## CITY OF DALLAS

## LANDMARK COMMISSION

Tuesday, July 5, 2022

## AGENDA

Plan to  
move  
fence over

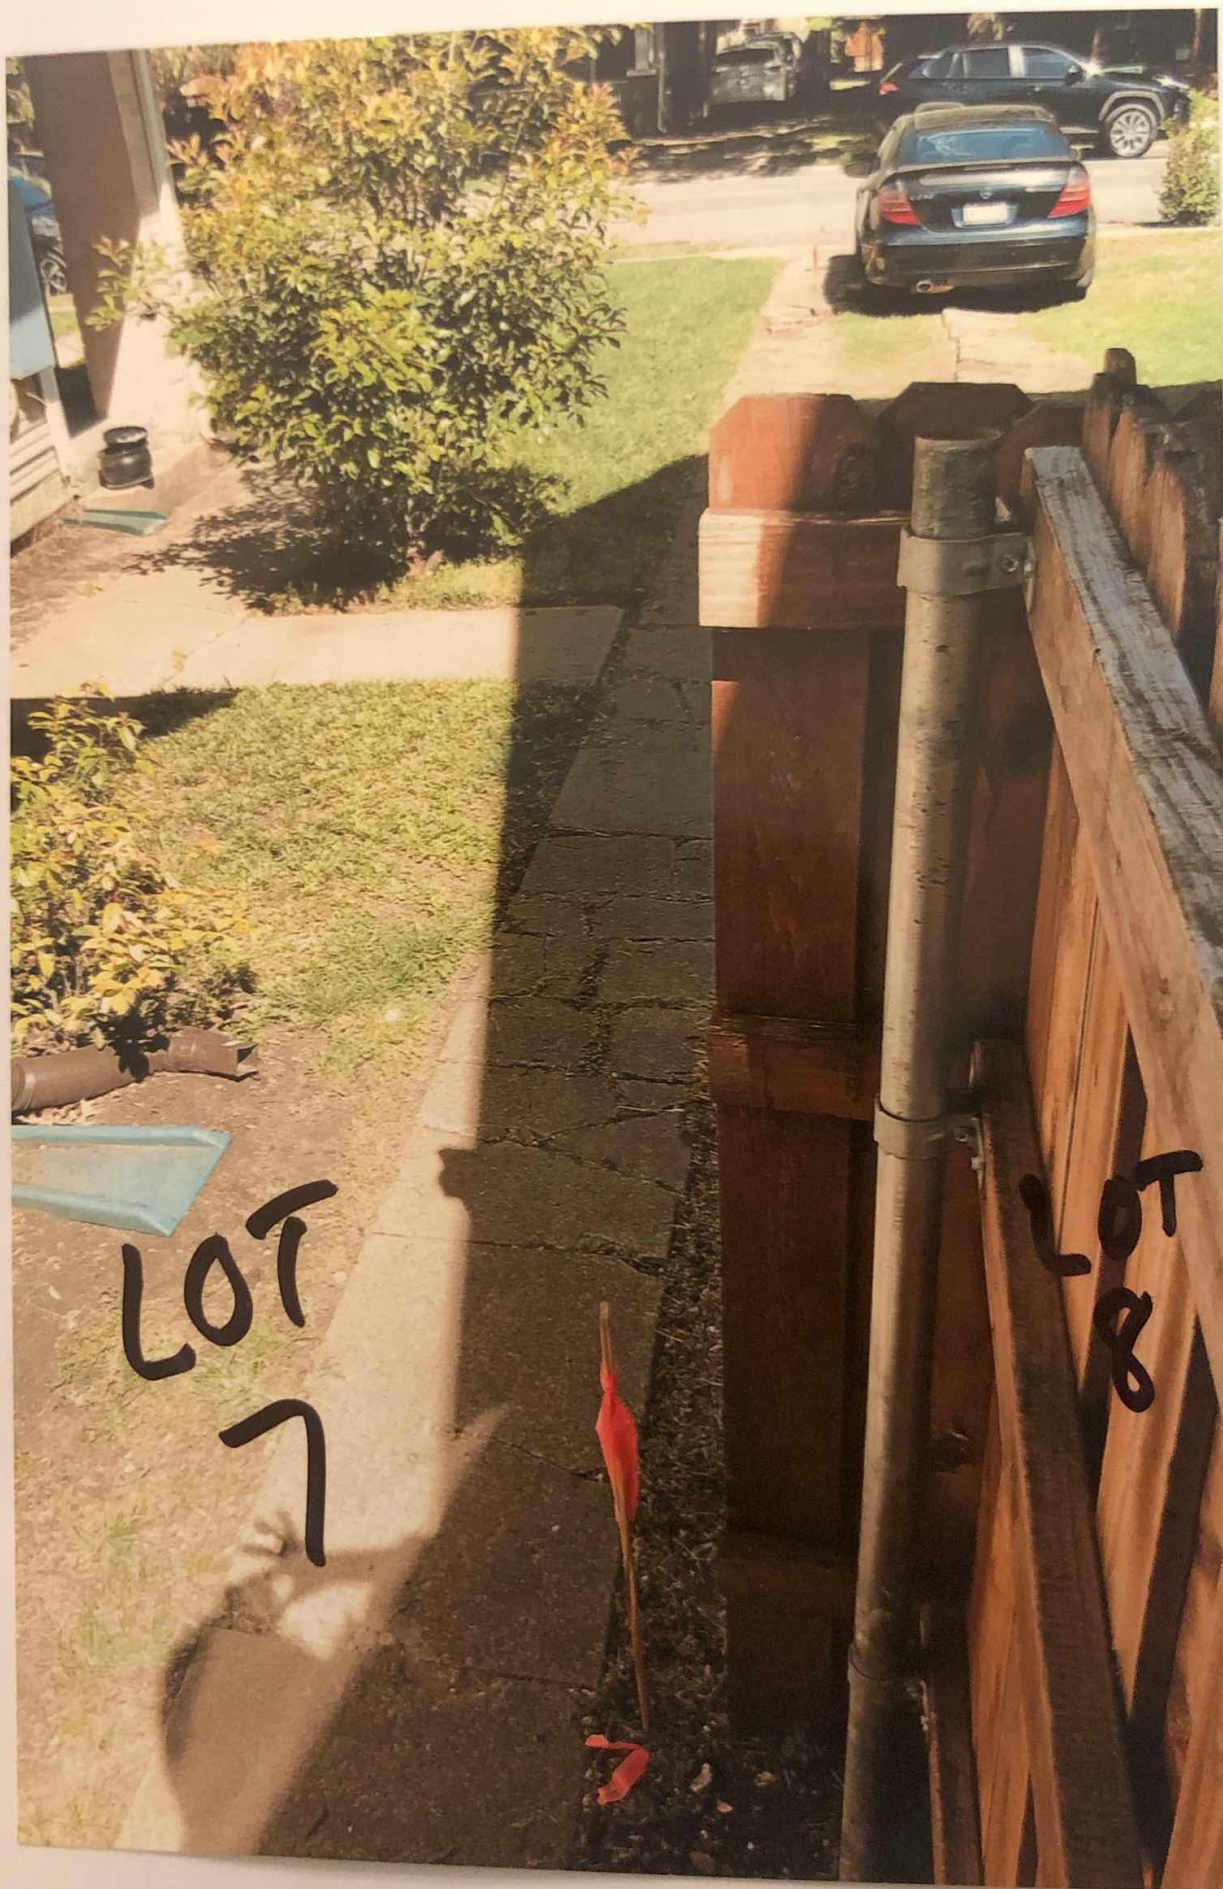
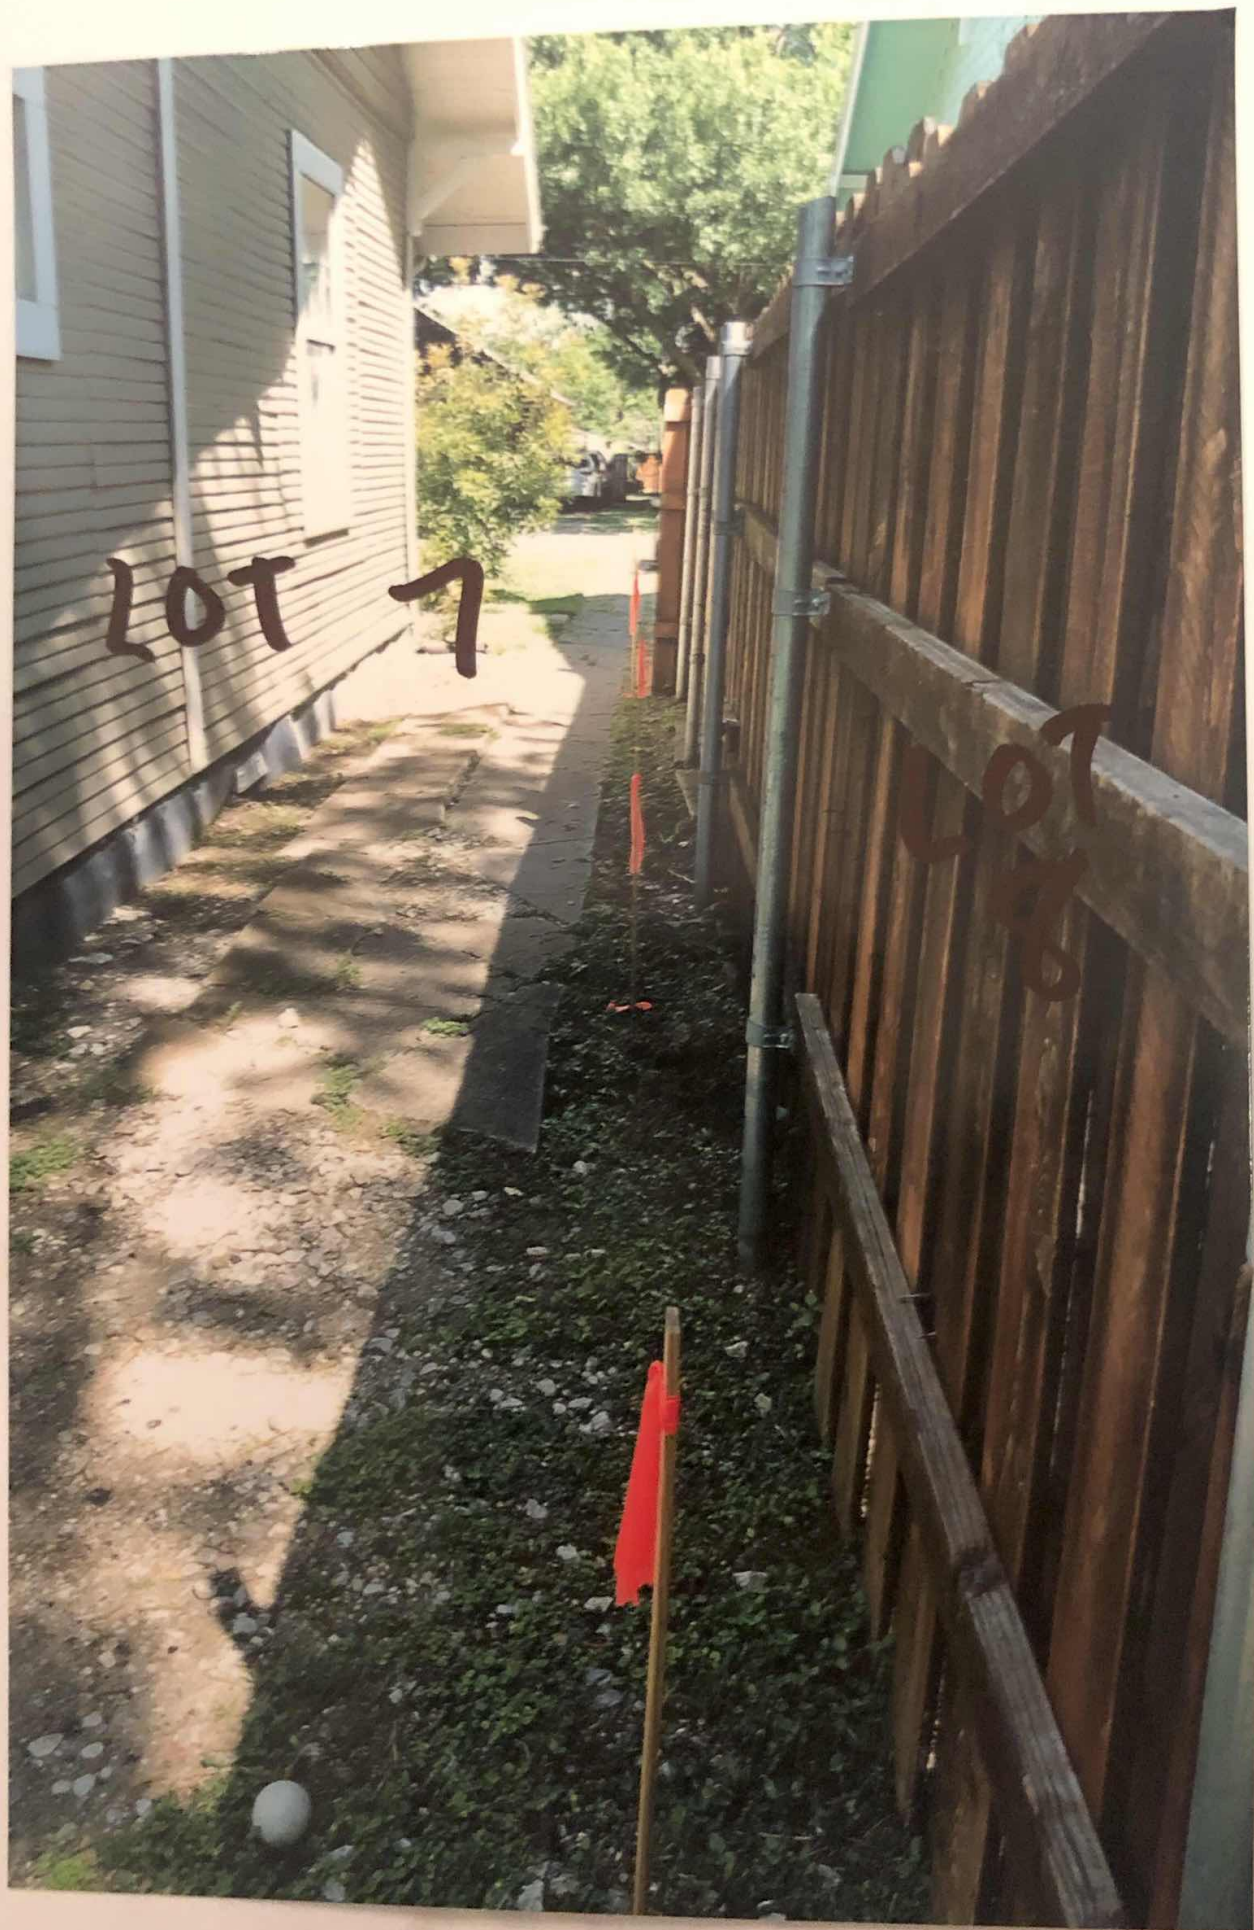
That the request for a Certificate of Appropriateness to replace existing interior side yard fencing to match property boundary be approved with the condition that the finished side needs to face neighbor's driveway.

That the request for a Certificate of Appropriateness to replace existing interior side yard fencing to match property boundary be approved in accordance with drawings and specifications dated 7/5/22 with the following condition: that the finished side of the fence must face out as it can be seen from the public right-of-way. The proposed work is consistent with Junius Heights preservation criteria Section 3.6 for Fences; City Code Section 51A-4.501(g)(6)(C)(i) for contributing structures; and the Secretary of the Interior's Standards.

Proposed fence extension.

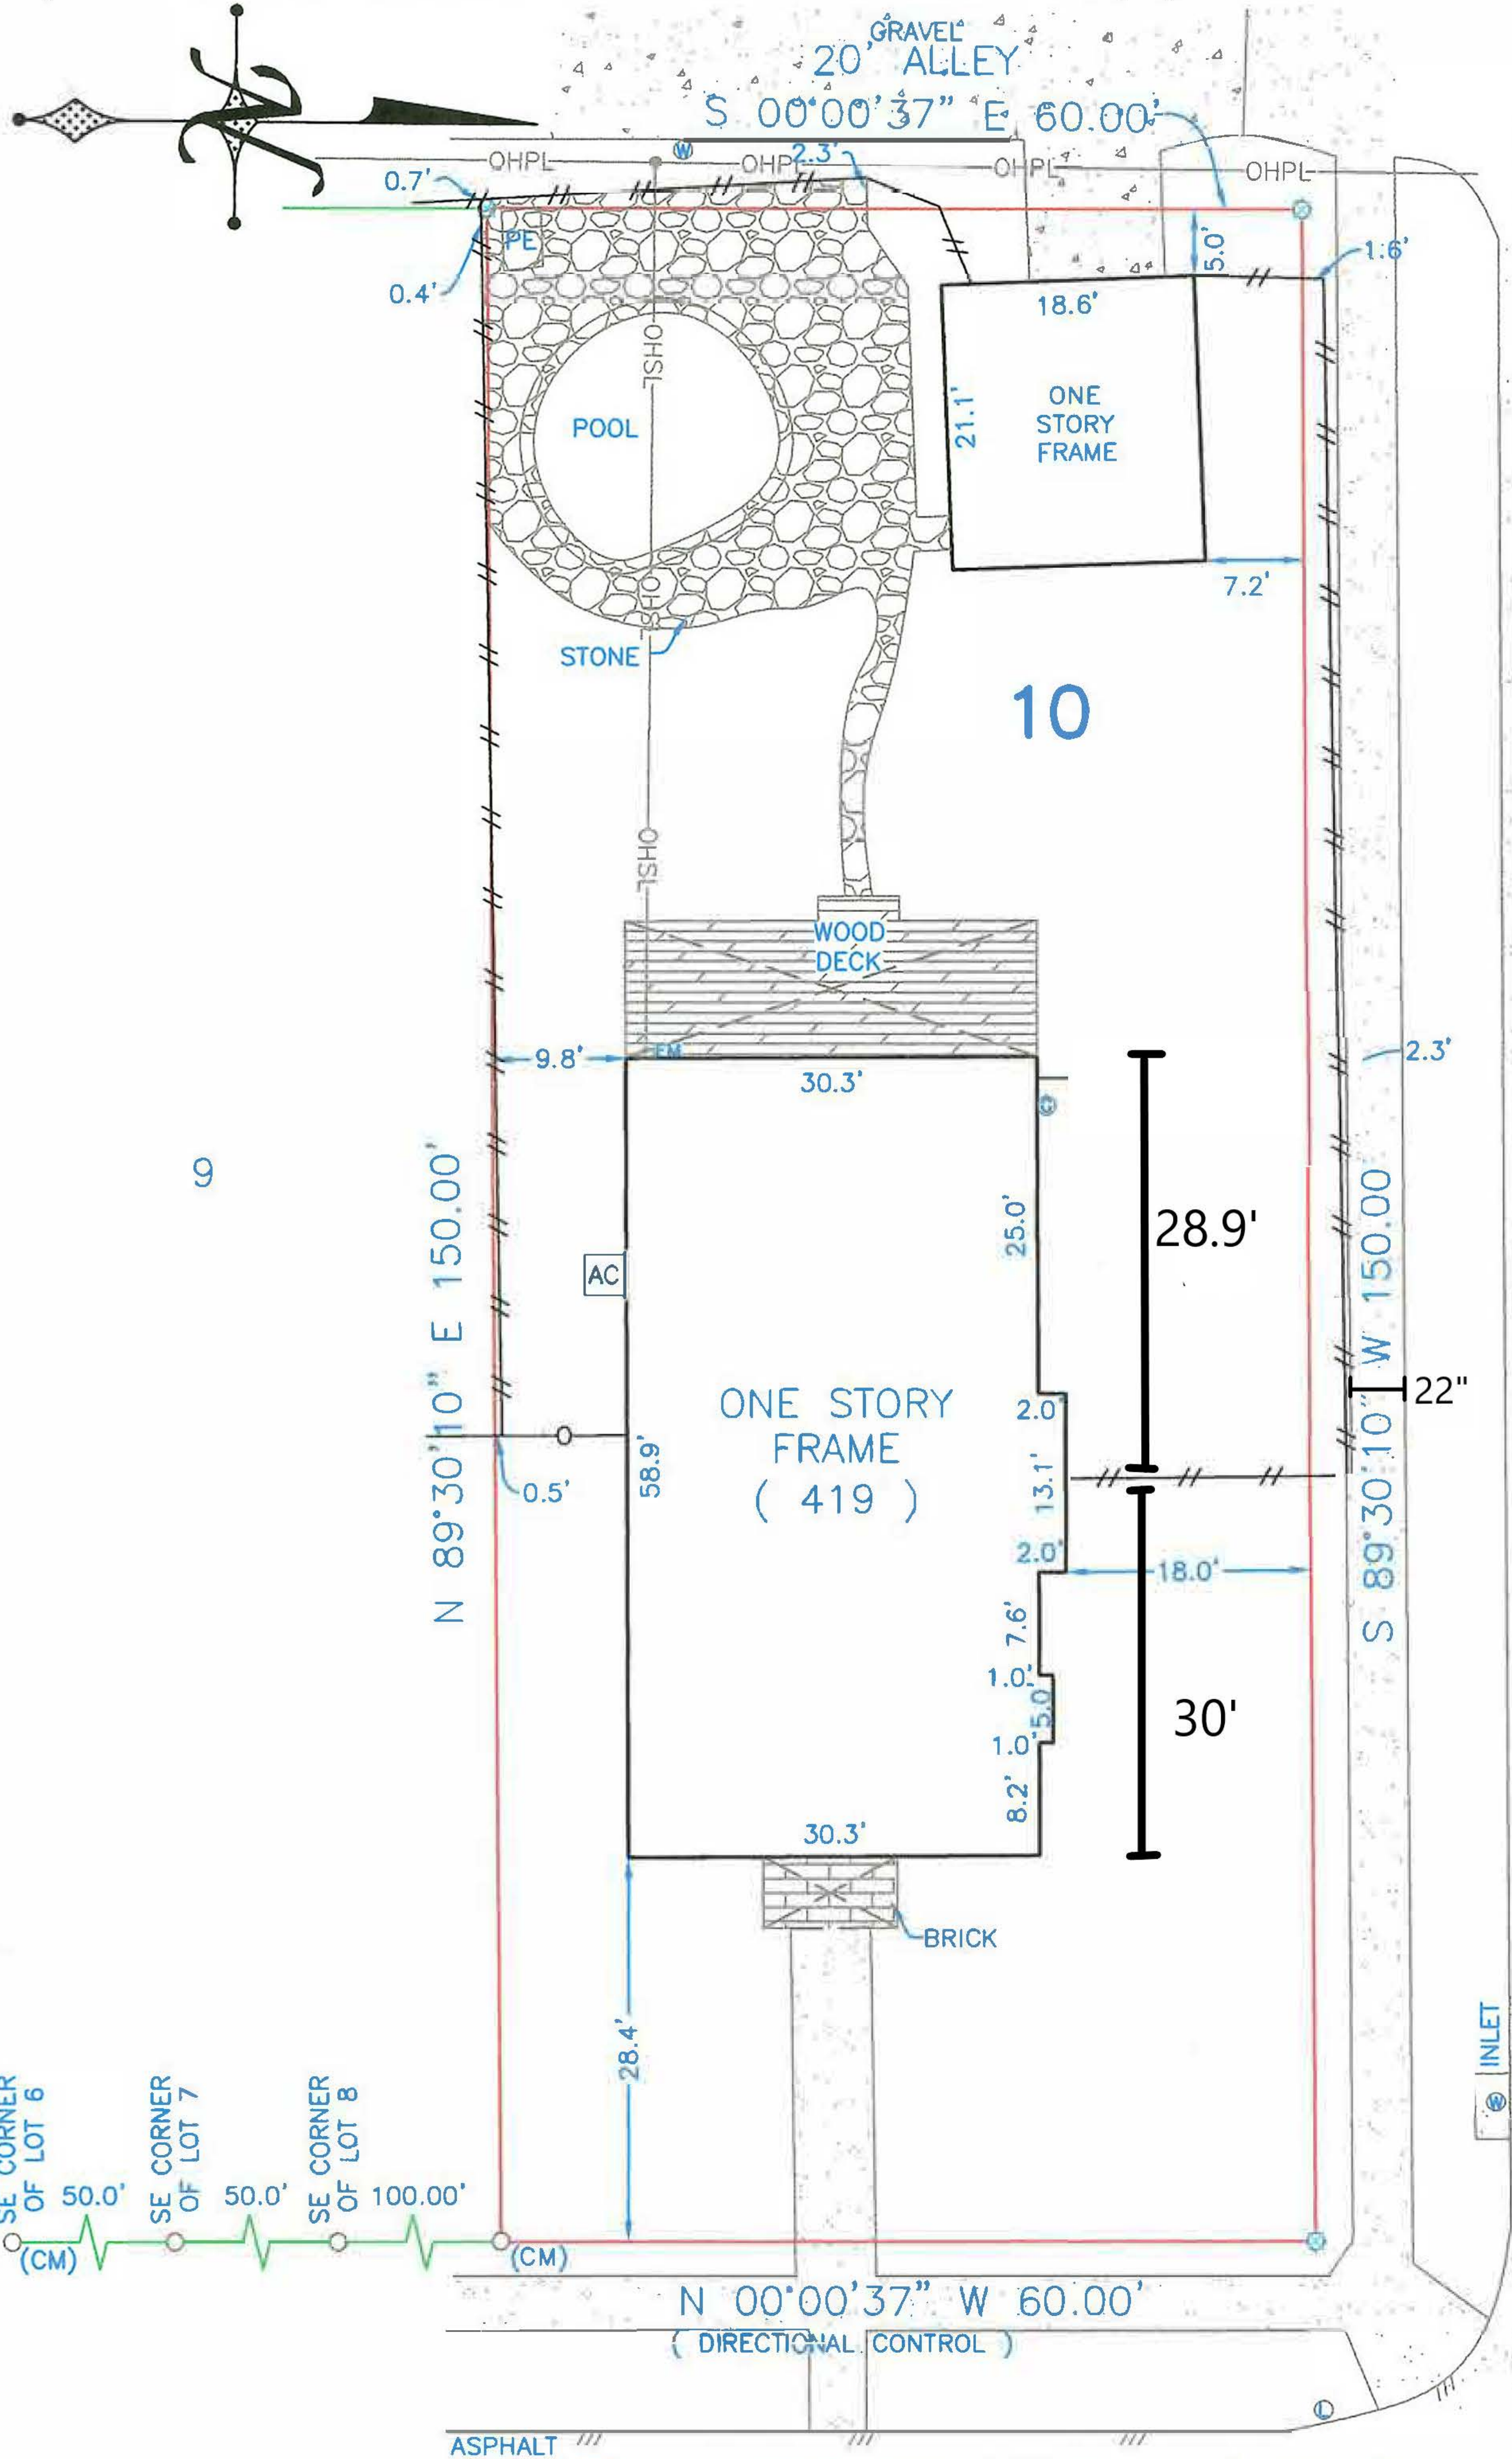
That the request for a Certificate of Appropriateness to extend an existing 8-ft stained wood fence be approved with conditions. Fence is allowed to be moved up to the 50% mark of the length of the house; however, the house is 58ft long rather than listed 60ft long. As well as there is a bump out two window feature that should not be divided by a fence. TF recommends moving the proposed fence location to the rear outside corner of the bump out, approx. 6ft back from the proposed location. It appears this will clear the tree and planting area.

*After the Task Force meeting, the applicant provided a revised site plan. However, the revised site plan is still inaccurate and does not meet the conditions specified by the Task Force.*
